Ref: Canal Run HOA Storm Water Lake Repairs

RMASSER <small>INSPECTED BY</small>	INSPECTOR'S REPORT	531046 <small>INSPECTION #</small>
11434 <small>PERMIT #</small>	CANAL RUN REGIONAL SWM/LAKE <small>PROJECT NAME</small>	
SWM MAINTENANCE TRIENNIAL INSP <small>TYPE OF INSPECTION</small>	Thu - 05/02/2013 <small>INSPECTION DATE</small>	FAILED <small>INSP STATUS</small>

Exhibit B – Supplemental Guidance to Exhibit A

Item #2: Forebay outlet window repair. Please refer to the following:

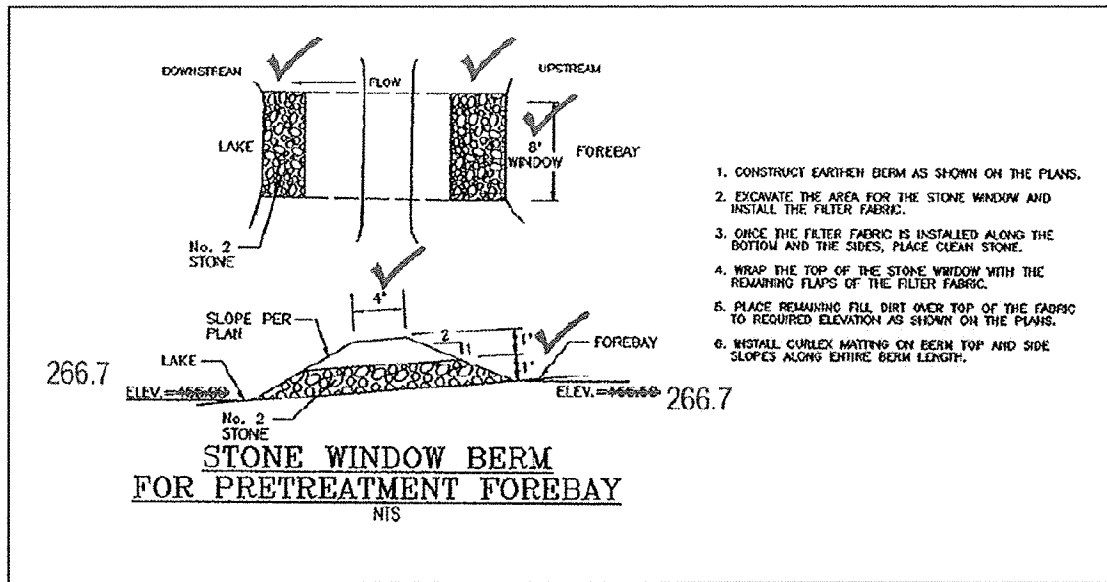
Above is an excerpt from the approved as-built redlines drawing.

- The area of the drawing detail I've highlighted in yellow represents where the earthen berm portion is currently missing [washed away] from the forebay outlets. The additionally highlighted numbers 5 and 6 are those steps required to repair these devices.

Item #3: Rip-Rap Outlet Protection [RROP] Repair.

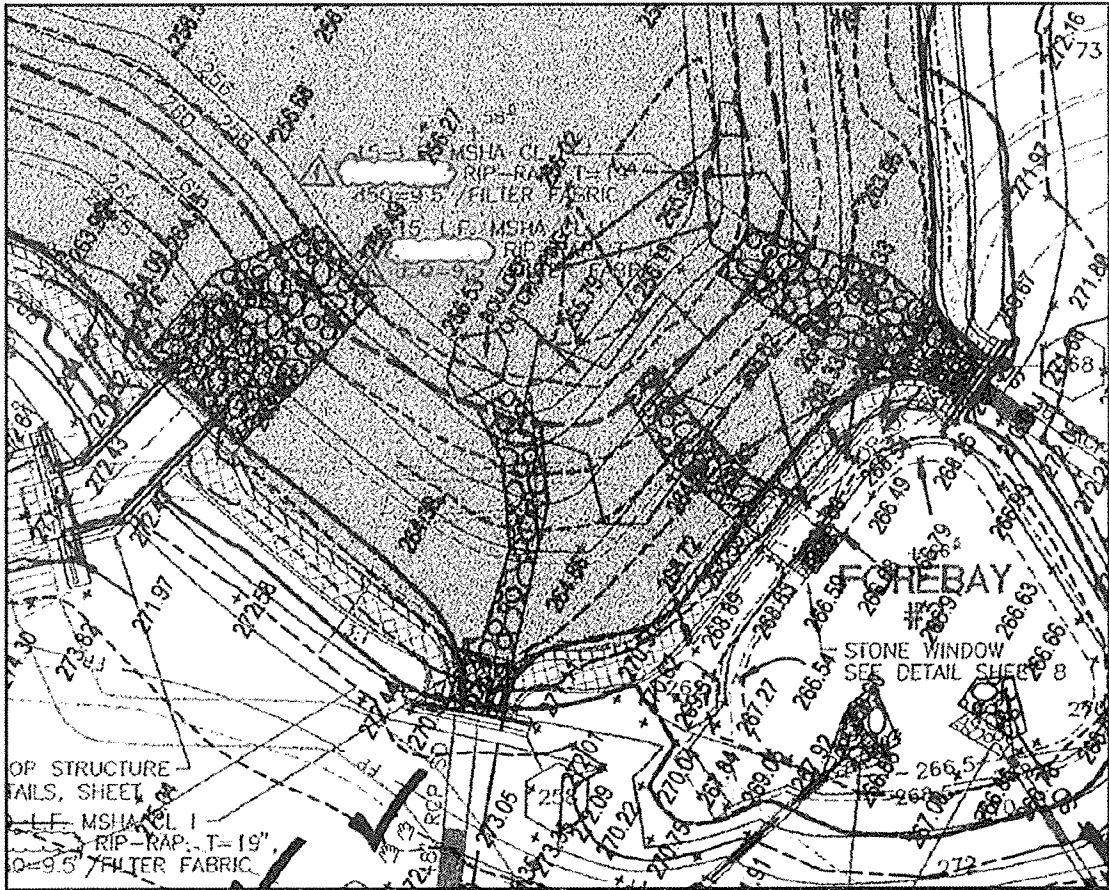
Above is an excerpt from the approved as-built redlines drawing.

- depicts an area in the southwest corner of the lake, where a lot [not all] of the damage occurred to the RROP.

*This depiction of the detail may not transmit with optimum clarity, so please allow me to clarify and more plainly state it.

Designed RROP:

- MSHA Class I Rip-Rap [Stones weighing no less than 2-LBS and no more than 150-LBS]
- Installed in a bed depth of 19-IN [Bed depth is measured below surrounding grade]
- $d_{50} = 9.5$ [50% of the stone diameter will be above 9.5-IN and 50% of the stone diameter will be below 9.5-IN]
- Installed over filter fabric

*Please note the Highlighted 'clouds' and 'call-out' symbol /1\.

The clouds cover what was originally specified to be "Grouted" [high slump concrete poured into the rip-rap bed]. This measure is generally used to fill the voids and lock the rip-rap together, making it a more cohesive unit that is less likely to be displaced.

However, call-out /1\ below states "Rev[ised] per MDE Comments"

- This would appear to suggest that grouting the rip-rap bed was not recommended by MDE.
- Based on the failure of the non-grouted rip-rap to hold in these areas, I recommend that grouting of the RROP be revisited with MDE (if necessary) and be restored as the recommended detail or be replaced with another detail. Options may include using larger rip-rap, embrocated rip-rap, gabion mattress or another material or procedure that can withstand the apparent velocity of flow entering the channels.
